Local Planning Panel

address: 163 Victoria Street, Potts Point

application: D/2026/ 650

- alterations and additions to existing terrace
- internal demolition
- change of use to a single dwelling

shadow impacts at 12pm (noon)

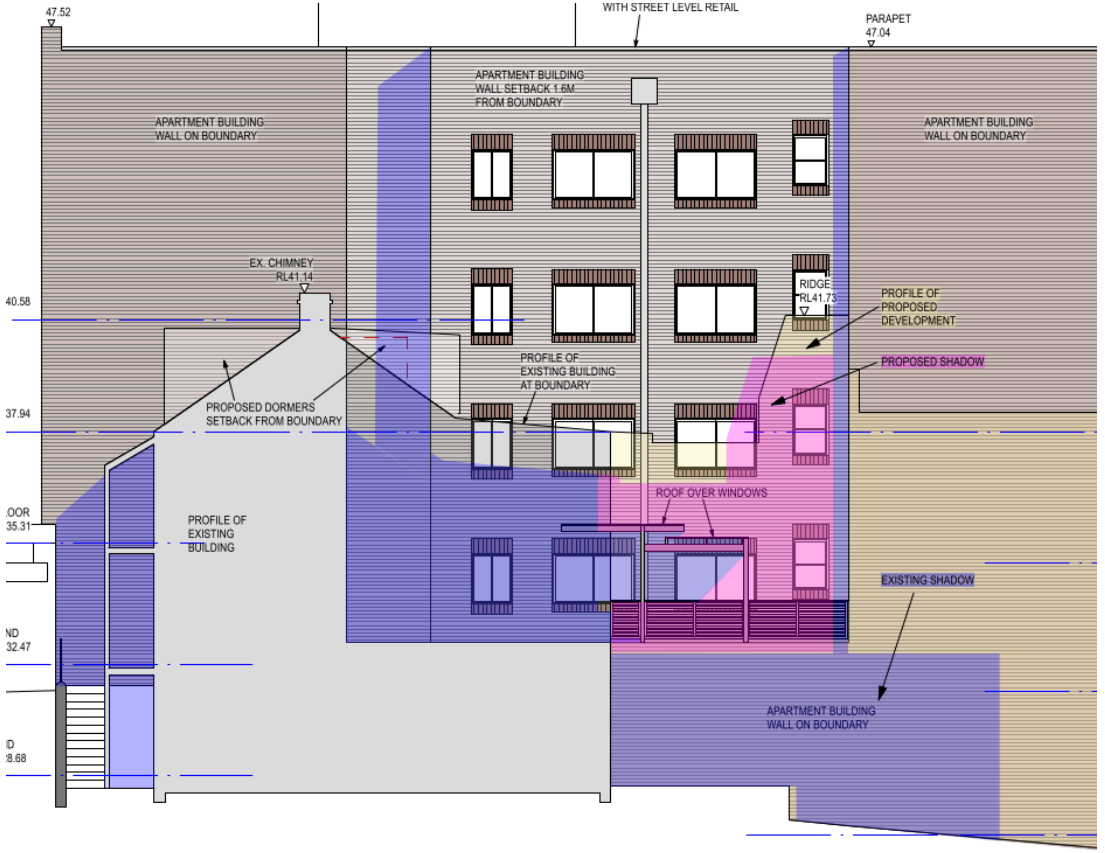
- overshadowing

existing view/outlook of unit 8/165-167 Victoria Street

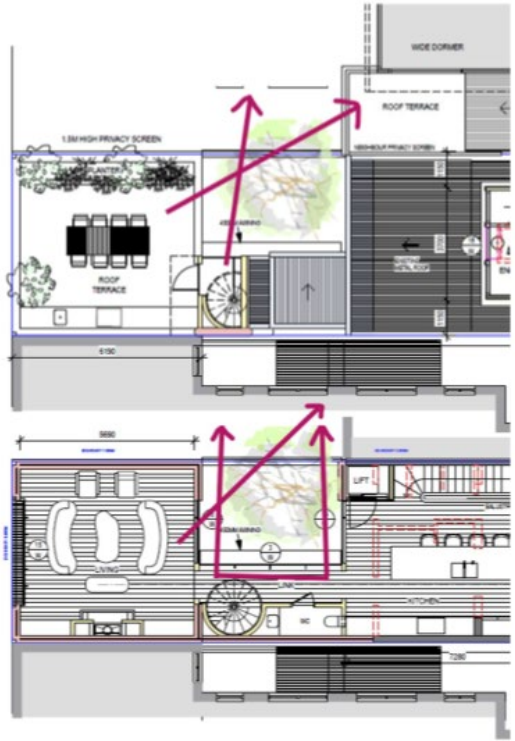
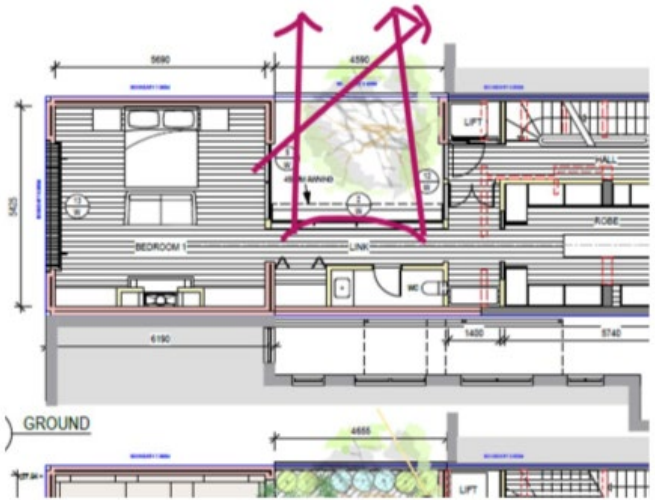
- loss of view

heritage

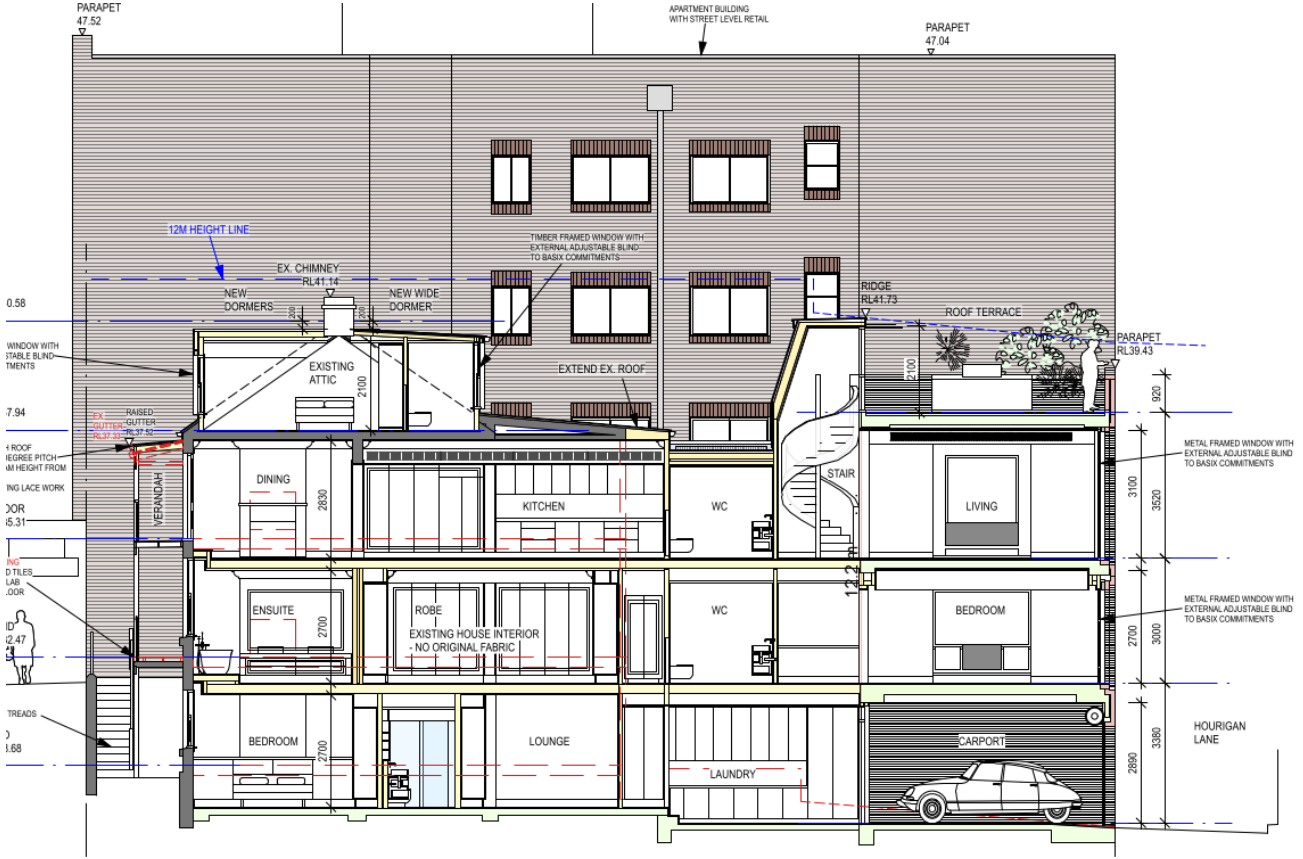
original

new
